SERVICE BULLETIN (No. 30)

INTERCHANGE AND SPECIFICATION CORRECTION

WEBB 63650 and 63652 BRAKE DRUMS

63650

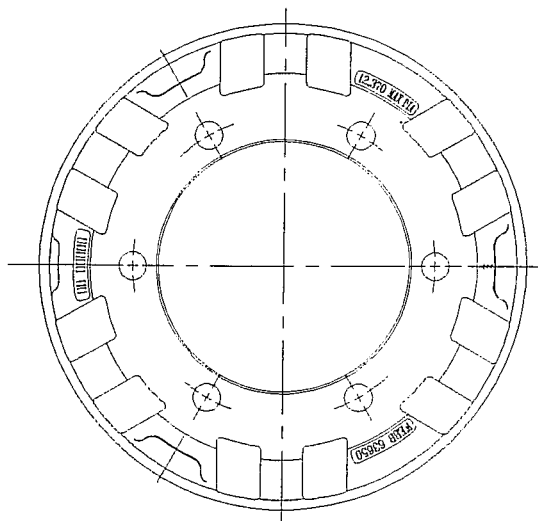
63650 Has 6 holes .81 in size — Holes are equally spaced

63652

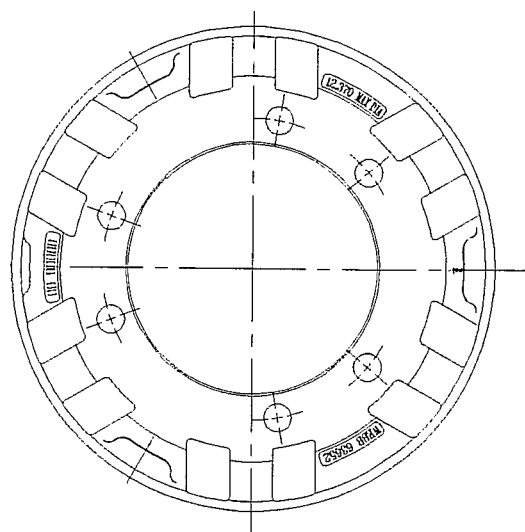
63652 Has 6 holes .81 in size — Holes are located in 3 pairs, 2 holes each
